DESIGN 	DRAWN BY 	DART AEROSPACE LTD HAWKESBURY, ONTARIO, CANADA	
CHECKED 	APPROVED 	DRAWING NO. DSI 9280	REV. A SHEET 1 OF 1
DATE 04.05.04		TITLE SUPPORT MODIFICATION	SCALE NTS
A	04.05.04	NEW ISSUE

DART SERVICE INSTRUCTION
TO AMEND INSTALLATION INSTRUCTIONS IIN-D212-664 REV. B
REF. CANADIAN STC: SH01-9 ISSUE 2
REF. FAA STC: SH01298NY

D2896-1
SUPPORT

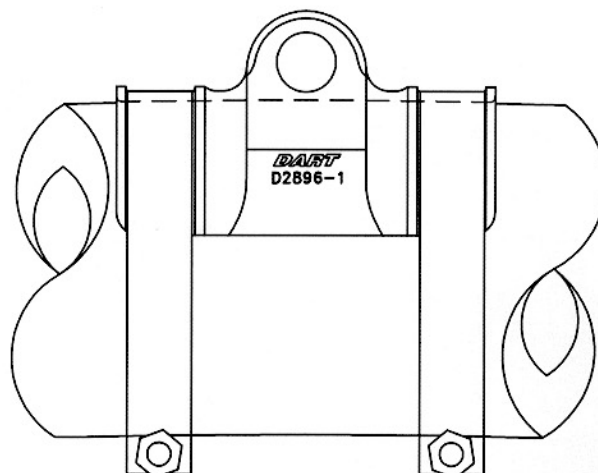
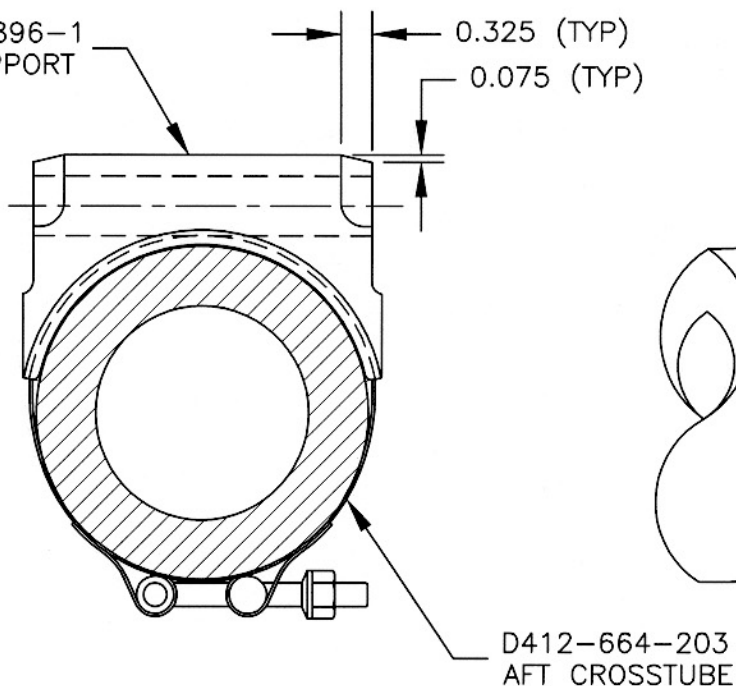
To prevent rocker beam interference during installation of D412-664-203 Crosstubes, it is permissible to relieve the D2896-1 Support as shown below. Touch-up with primer & paint per ICA-D212-664.

0.325 (TYP)

0.075 (TYP)
